Docket Nos.: 50-321 50-366 NL-19-0329

Edwin I. Hatch Nuclear Plant Units 1 and 2 Revise Technical Specification Requirements During Handling Irradiated Fuel and Core <u>Alterations – TSTF-51</u>

The enclosure provides a basis for the proposed change, including a proposed no significant hazards considerations analysis. Attachments 1 and 2 contain marked-up TS pages and revised TS pages, respectively. Attachment 3 contains revised TS Bases pages marked to show the accompanying proposed changes for information only.

APPLICABILITY: MODES 1, 2, and 3, During movement of firradiated fuel assemblies in the secondary containment, During CORE ALTERATIONS.

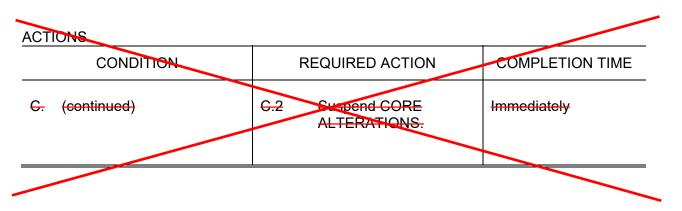
- Applicability is revised to state, in part, "During movement of *recently* irradiated fuel assemblies in the secondary containment, During CORE ALTERATIONS."
- Condition C is revised to state, "Secondary containment inoperable during movement of *recently* irradiated fuel assemblies in the secondary containment-or during CORE ALTERATIONS."
- Required Action C.1 is revised to state, "Suspend movement of *recently* irradiated fuel assemblies in the secondary containment," and Required Action C.2 and associated logical connector "AND" and "Immediately" Completion Time are deleted. TS Actions table formatting is revised to support the proposed required action deletion.

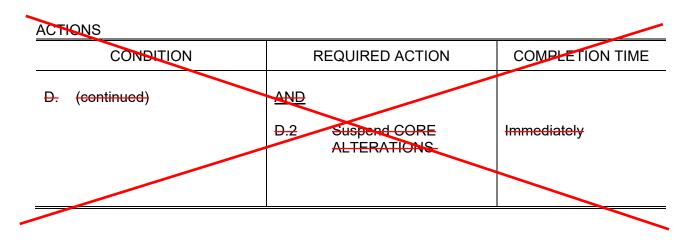
- Applicability is revised to state, in part, "During movement of *recently* irradiated fuel assemblies in the secondary containment, During CORE ALTERATIONS."
- Condition D is revised to state, "Required Action and associated Completion Time of Condition A or B not met during movement of *recently* irradiated fuel assemblies in the secondary containment-or during CORE ALTERATIONS."
- Required Action D.1 is revised to state, "Suspend movement of *recently* irradiated fuel assemblies in the secondary containment," and Required Action D.2 and associated logical connector "AND" and "Immediately" Completion Time are deleted. TS Actions table formatting is revised to support the proposed required action deletion.

| - | | CONDITION | R | EQUIRED ACTION | COMPLETION TIME |
|-------|----------------|---|--|---|------------------------|
| recen | D. | Required Action and associated Completion Time of Condition A or B not/met during movement of frradiated fuel assemblies in the secondary containment-or during CORE ALTERATIONS. | D.1 | NOTE LCO 3.0.3 is not applicable. Suspend movement of irradiated fuel assemblies in the secondary containment. | Immediately |

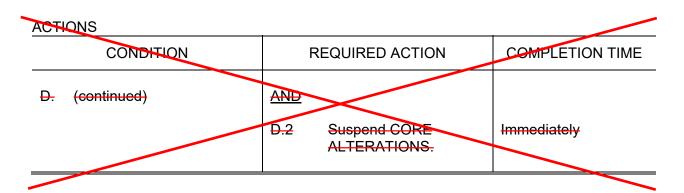
| | CONDITION | | REQUIRED ACTION | | COMPLETION TIME |
|-------|-----------|--|-------------------|--|------------------|
| recen | D. | Required Action and associated Completion Time of Condition A or B not met during movement of irradiated fuel assemblies in the secondary containment-or during CORE ALTERATIONS. | D.1 | NOTE LCO 3.0.3 is not applicable. Suspend movement of irradiated fuel assemblies in the secondary containment. | Immediately |
